**SERVICE BULLETIN**

**N° 189-233**

**ATA 65 – IGB BOLTS RETROMOD INSTALLATION**

**Figure 1**

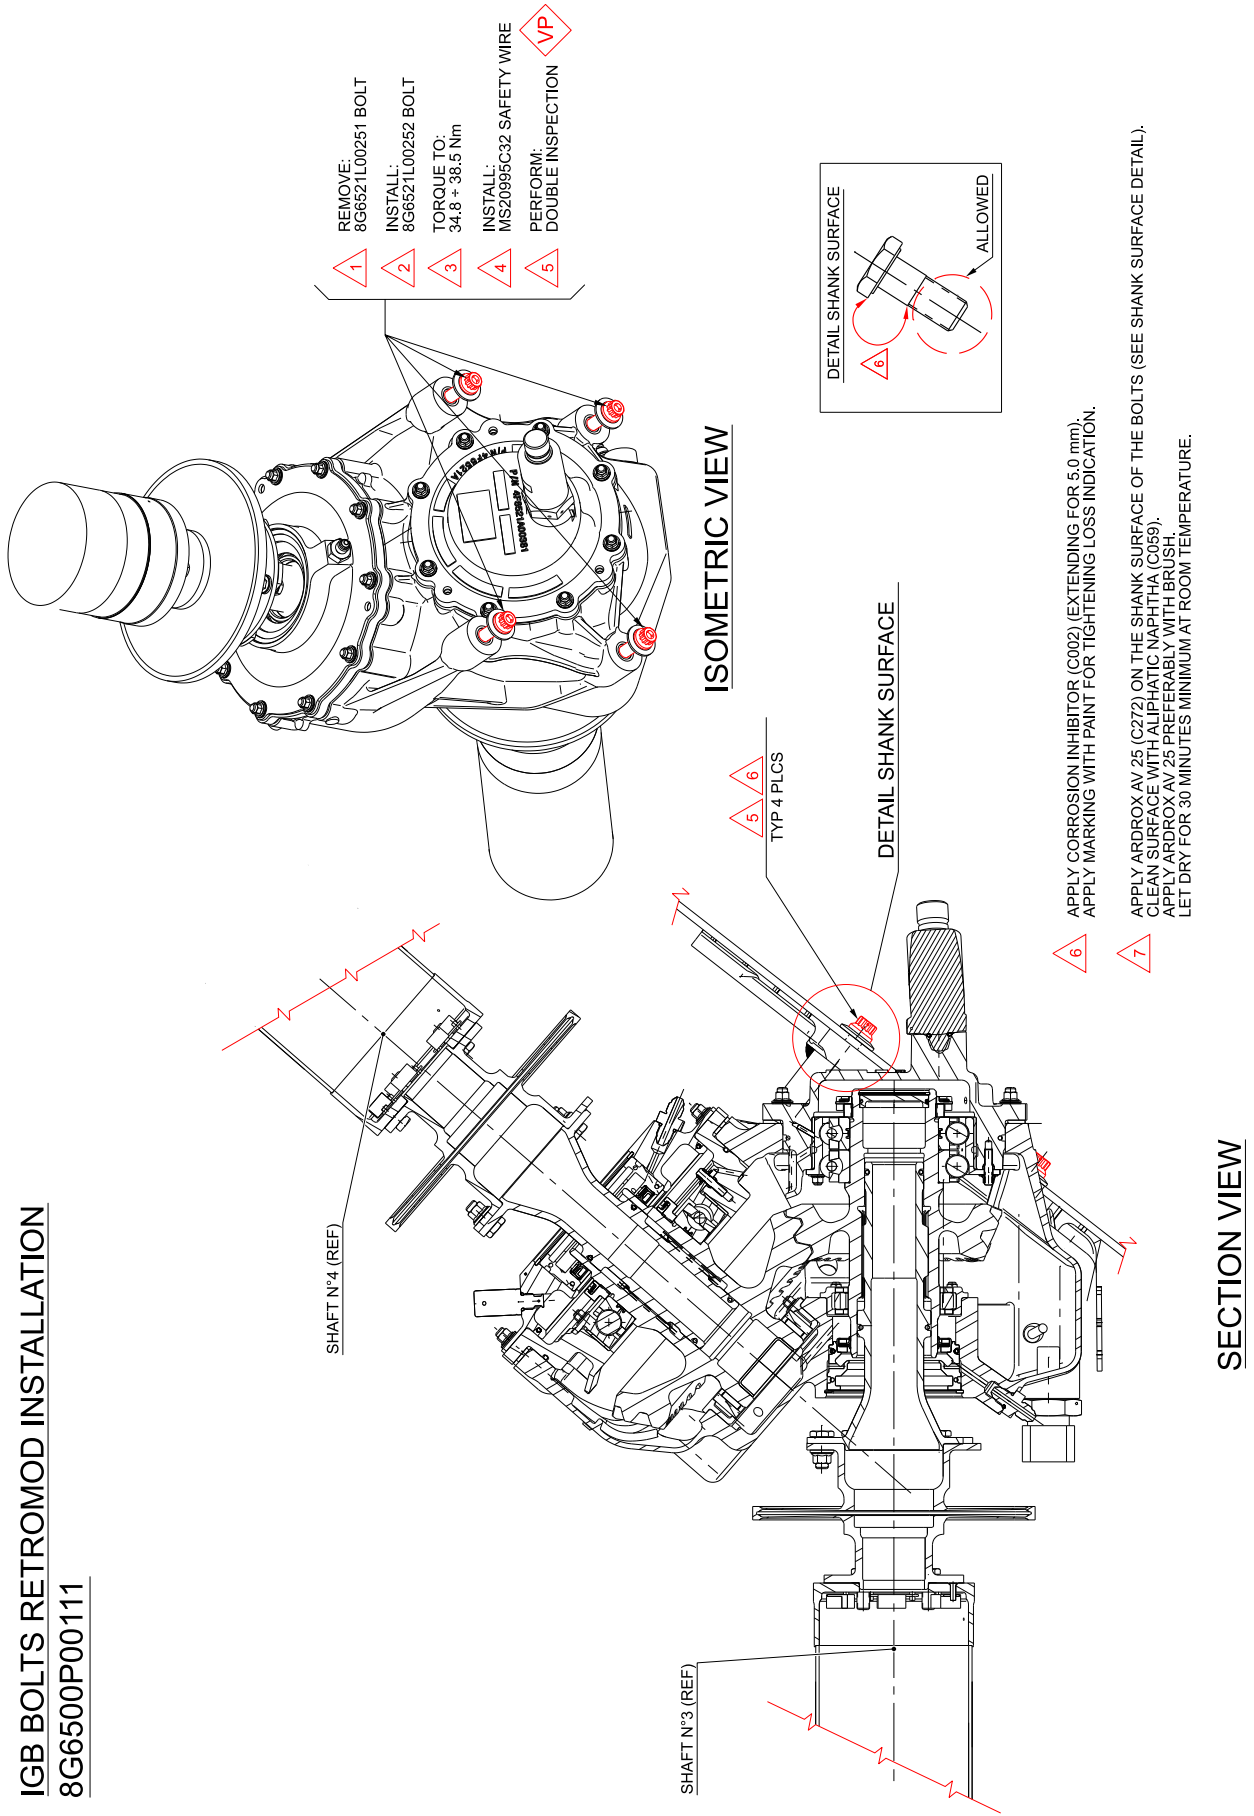
Leonardo Helicopter Division updated the design of the IGB attachment in order to avoid any risk of interference between the four attaching bolts and the structure. This new design replaces the existing n°4 fixing bolts of the IGB with n°4 new bolts P/N 8G6521L00252 that have a different grip length and the same total length.

- 3.1 In accordance with the applicable steps of AMP DM 89-A-65-21-01-00A-520A-A and with reference to Figure 1 Isometric View, remove and discard one of the n°4 existing bolts P/N 8G6521L00251.
- 3.2 With reference to Figure 1 Section View, clean the shank surface of the bolt P/N 8G6521L00252 by means of aliphatic naphtha (C059).

- 3.3 With reference to Figure 1 Section View, apply corrosion inhibitor Ardrox AV 25 (C272) on the shank surface (allowed area shown on Figure) of the bolt P/N 8G6521L00252 using a brush.

- 3.4 With reference to Figure 1 Isometric View, install the bolt P/N 8G6521L00252 that attach the IGB to the tail structure. Torque the bolt to 24÷28 Nm (212÷248 lbf/in).

- 3.5 Perform again Steps 3.1 to 3.4 to install the other three bolts P/N 8G6521L00252.
- 3.6 With reference to Figure 1 Isometric View, tighten the four bolts to the final torque value of 34.8÷38.5 Nm (308÷341 lbf/in) in a cross sequence.

- 3.7 In accordance with applicable steps of AMP DM 89-A-65-21-01-00A-720A-A and with reference to Figure 1 Isometric View, safe the four bolts P/N 8G6521L00252 in pairs with the new safety wire P/N MS20995C32. Protect the wire with insulating tube P/N B7444-1-1-9C (C049).

- 3.8 With reference to Figure 1 Section View, protect the indicated bolts head, nuts and washers with a layer of corrosion inhibitor (C002). Extending the application for 5.0 mm onto the surrounding main component surfaces as applicable.

- 3.9 With reference to Figure 1 Section View, apply anti-slippage marks on the four bolts P/N 8G6521L00252.
